Bay Arenac ISD Dining Room Addition
and Interior Renovations
Bay City, Michigan

ADDENDUM NO. 5

Date: September 18, 2026
TSSF Project # 2538

MASTER FIRST FLOOR PLAN
SCALE: 1/32" = 1'-0"

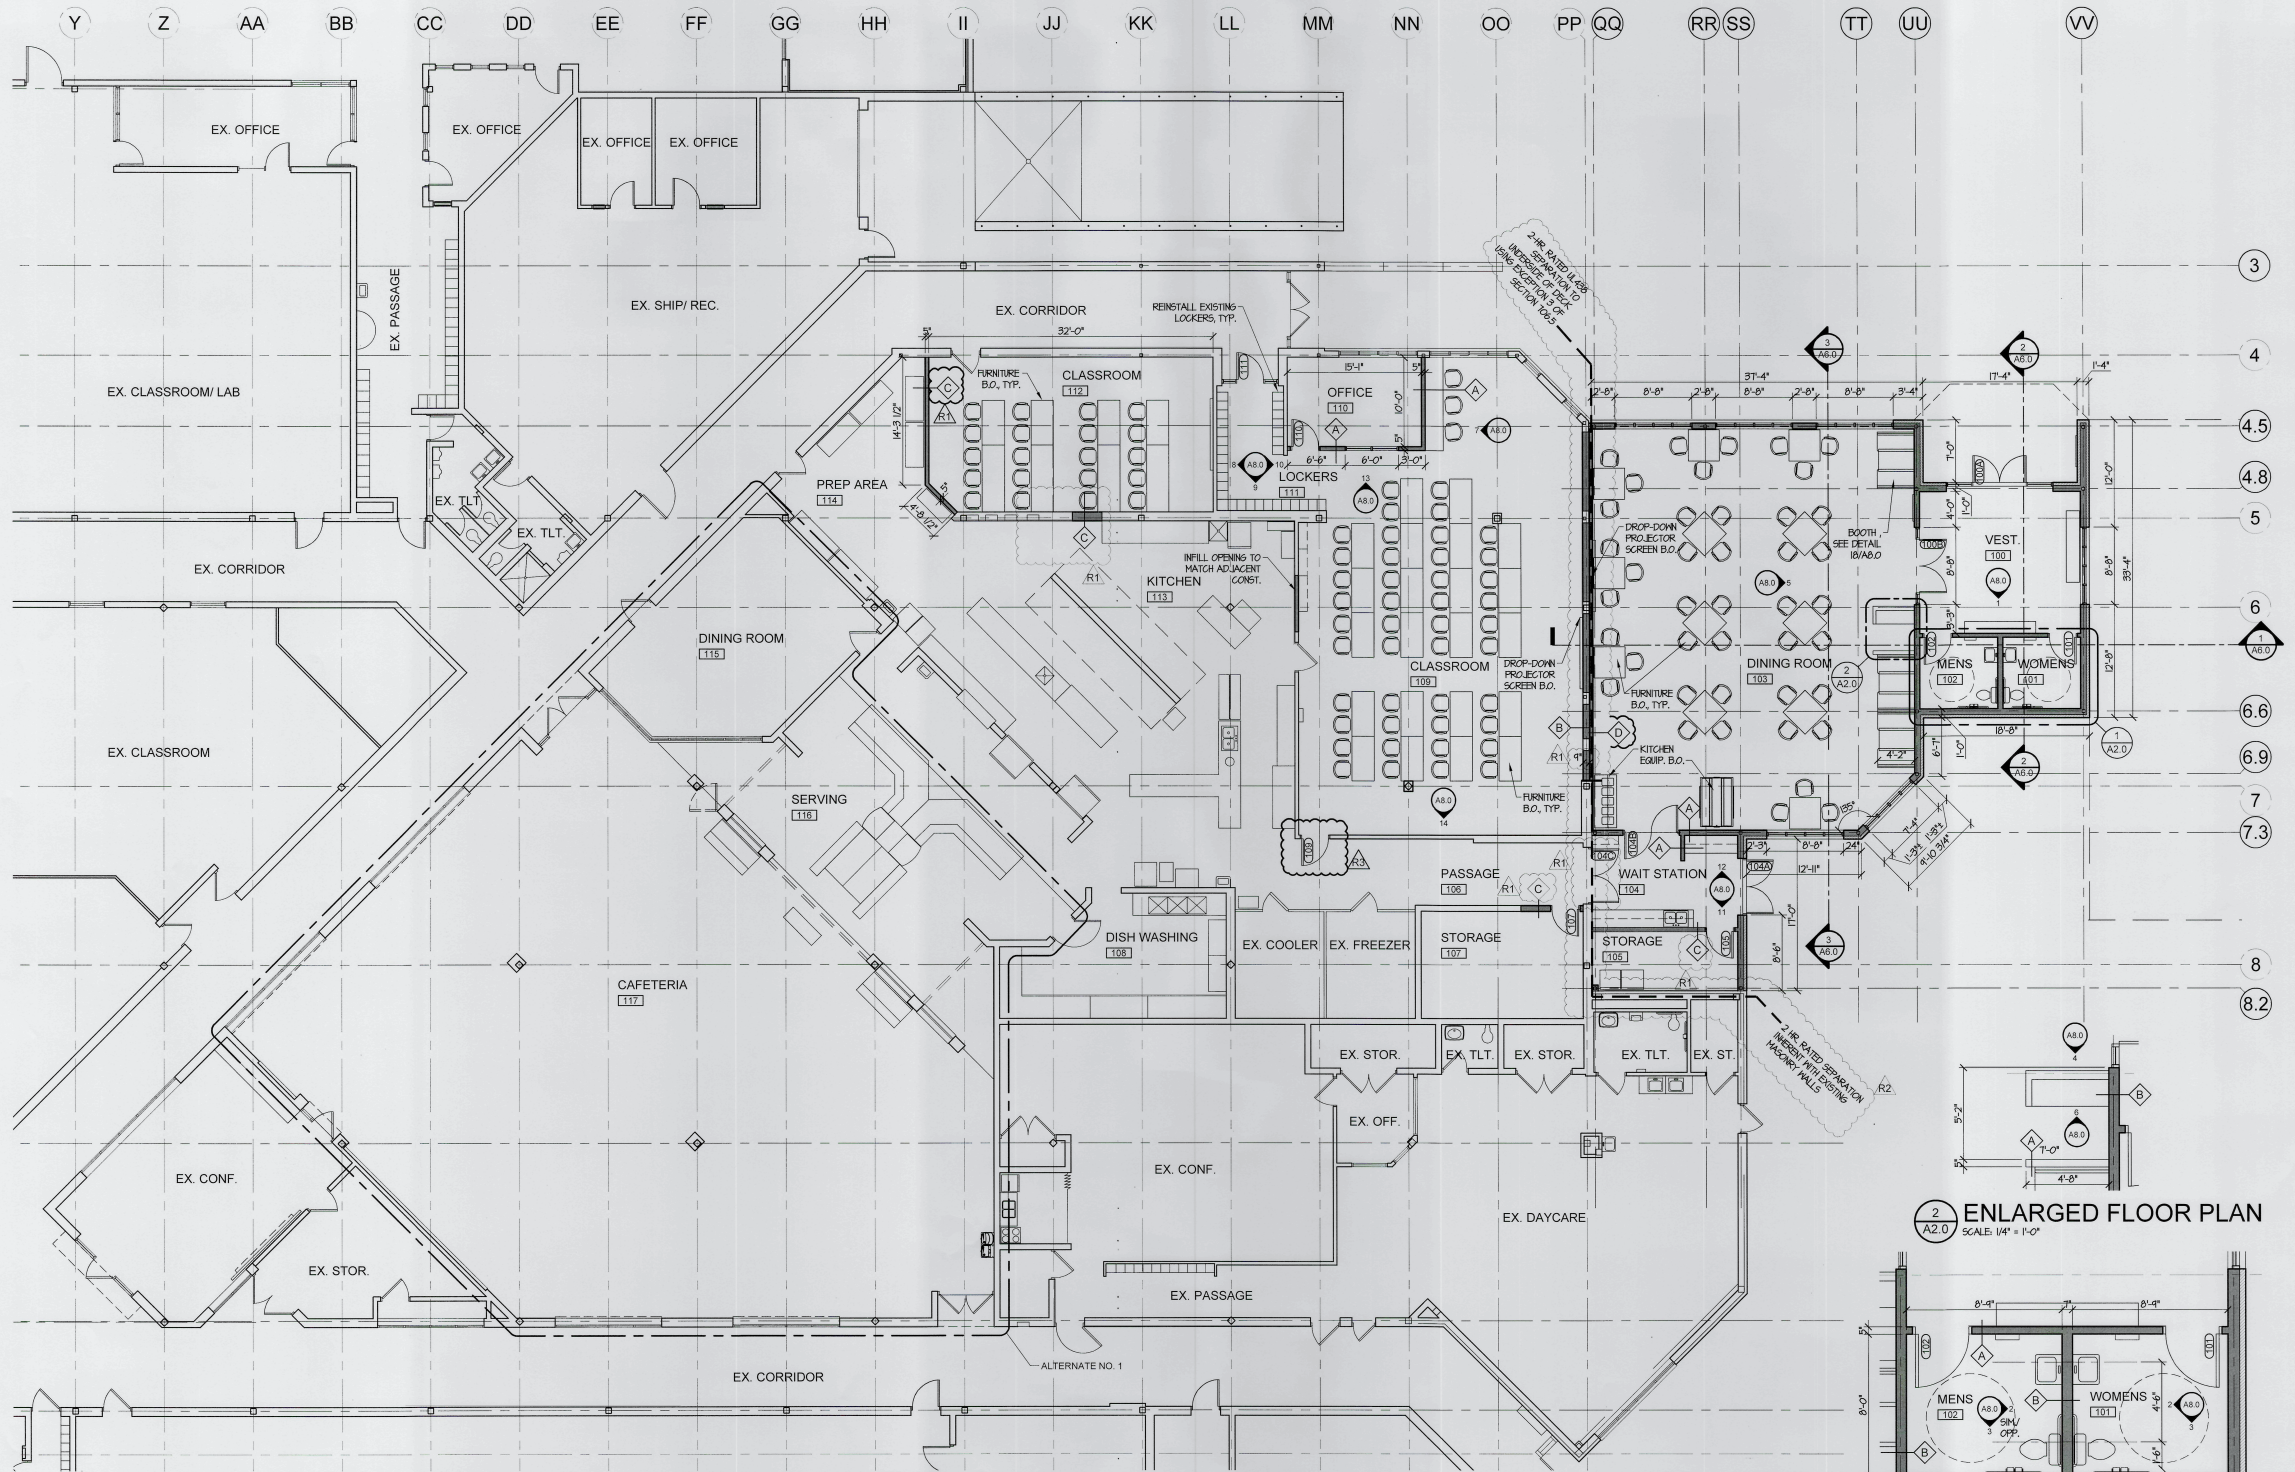
Item A1: **See revised sheet A0.1 (re-issued):** See revisions shown clouded.
a. Revised Classroom 109 door and added travel distance notation for second exit.
b. As noted previously in the last revision My Code path is using this exception in the MBC 2021 Section 706.5:
3. Fire walls shall be permitted to terminate at the interior surface of noncombustible exterior sheathing where the building on each side of the fire wall is protected by an automatic sprinkler system installed in accordance with Section 903.3.1.1 or 903.3.1.2.
